ABBREVIATED PLAT AGENDA

A. **HATCHER PASS VILLAGE PHASE IX:** The request is to create three lots from Tract A-7, Hatcher Pass Village Phase III, Plat No. 2022-132 to be known as **HATCHER PASS VILLAGE PHASE IX**, containing 9.74 acres +/- . The property is located north of E. Edgerton Parks Road, east of N. Moose Lick Circle, and directly west of N. Mountain Trails Drive (Tax ID # 8332000T00A-7); within the NE ¼ Section 33, Township 19 North, Range 01 East, Seward Meridian, Alaska. In the Fishhook Community Council and in Assembly District #6. *(Petitioner/Owner: Chris Soloy, Staff: Matthew Goddard, Case #2024-132)*

STAFF REVIEW AND RECOMMENDATIONS
PUBLIC HEARING
OCTOBER 4, 2024

ABBREVIATED PLAT: HATCHER PASS VILLAGE PH IX
LEGAL DESCRIPTION: SEC 09, T17N, R02E, SEWARD MERIDIAN AK
PETITIONERS: HATCHER PASS VILLAGE INC.
SURVEYOR/ENGINEER: HANSON LAND SOLUTIONS / PIONEER ENGINEERING
ACRES: 9.74 ± PARCELS: 3
REVIEWED BY: MATTHEW GODDARD CASE #: 2024-132

TEST HOLE LOCATION EXHIBIT MAP

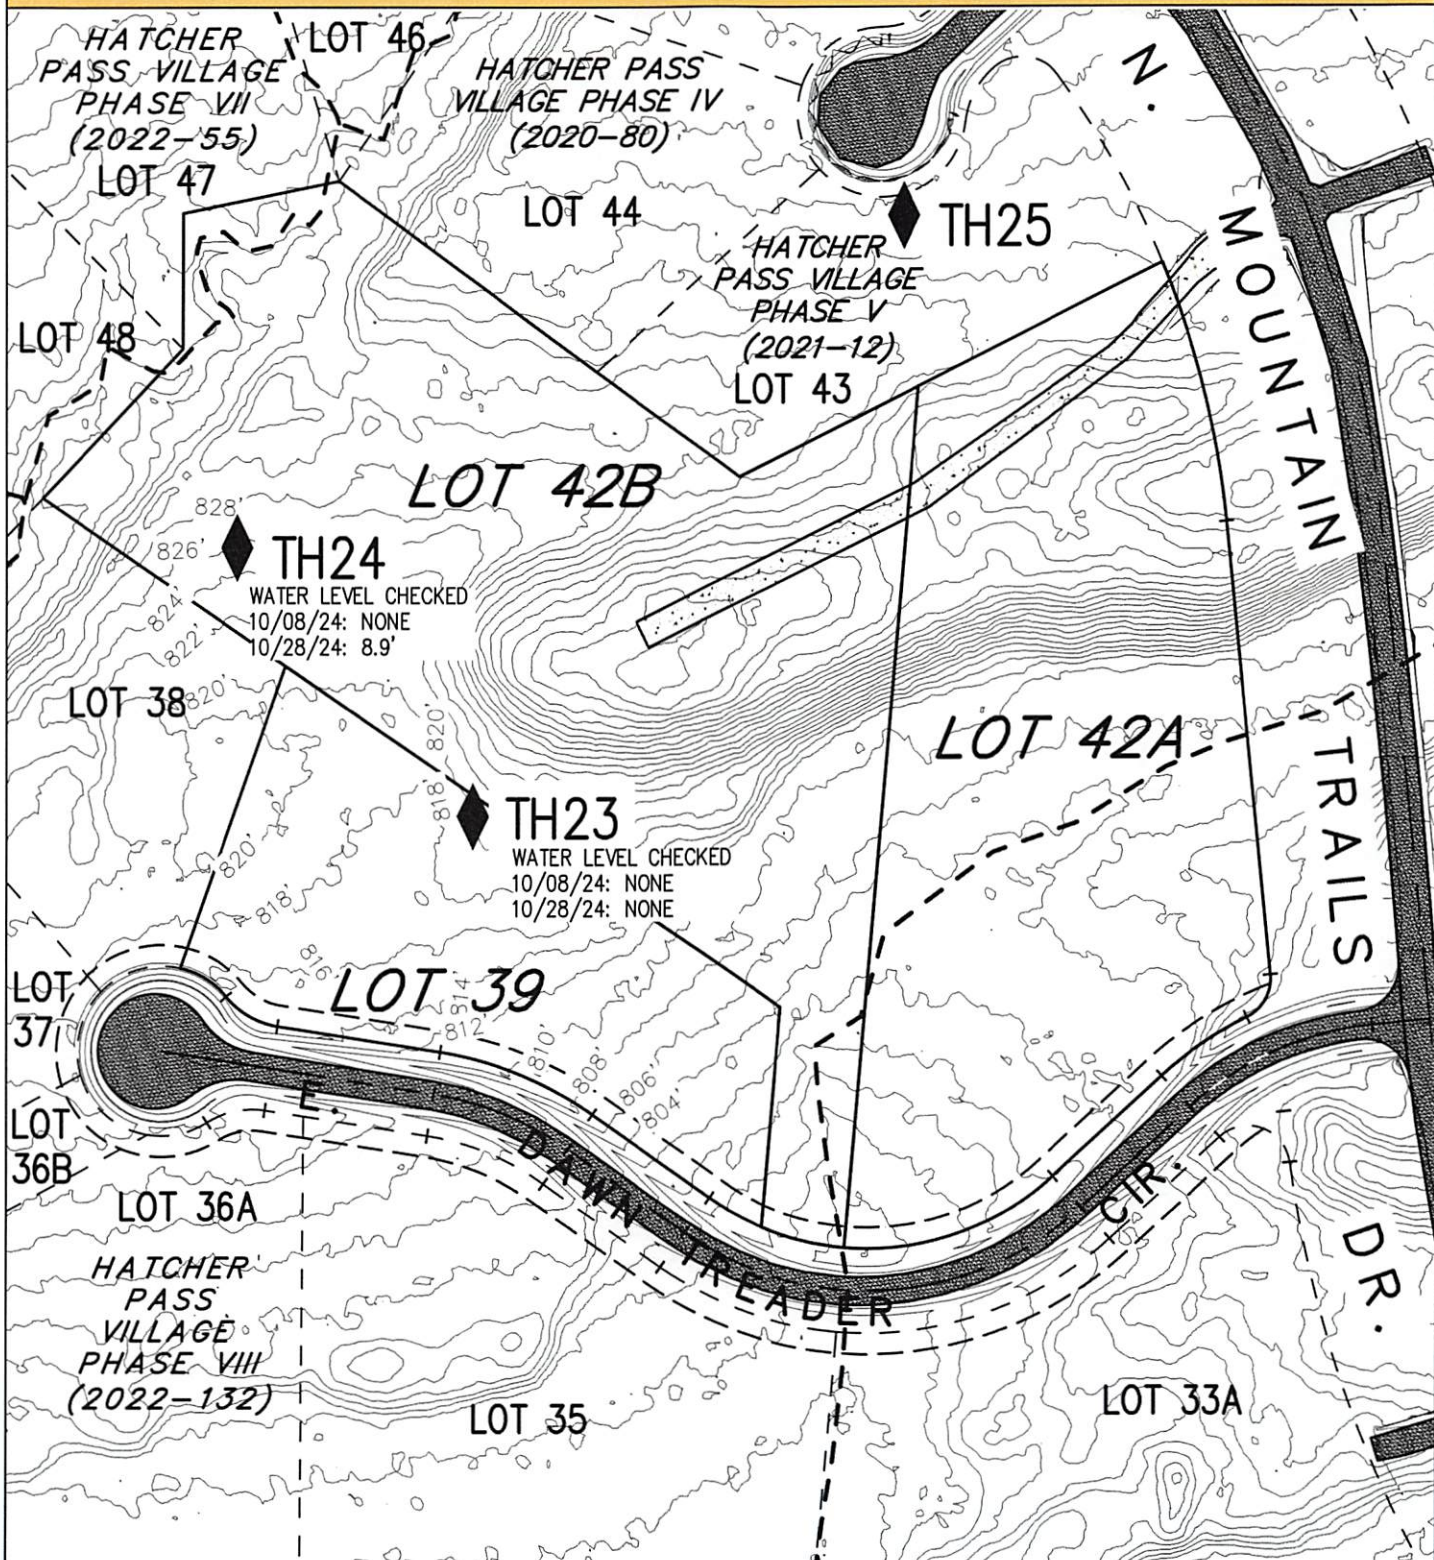
MSB DPW Pre-Design and Engineering (**Exhibit D**) notes that a plat note should be added stating that all lots are to take access from Dawn Treader Circle (**Recommendation #4**). Test Hole #23 and Test Hole #24 are at a much different elevation than the useable area on Lot 42A. Test Hole #205 from the original Hatcher Pass Village master plan on proposed lot 42A shows bed rock at 6' with shallow groundwater perched on top. Please provide evidence of useable area on Lot 42A (**Recommendation #5**).

A note on the plat should be added that all lots take access from Dawn Treader Circle. TH23 and TH24 are at a much different elevation than the useable area on Lot 42A. TH205 from the original Hatcher Pass Village master plan on proposed lot 42A shows bed rock at 6' with shallow groundwater perched on top. Please provide evidence of useable area on Lot 42A.

Test hole 25 is outside of the perimeter of the proposed subdivision and therefore can't be used for determining suitability of soils for useable septic area per 43.20.281(A)(1)(b).

Test hole 205 is indeed shallow with bedrock and water. Because of that, we merged the entire proposed lot down there there with lot 42 to the north. Test hole 25, also from the original Master Plan, is referenced on the report and is representative of what is up on the hill where the usable area is.
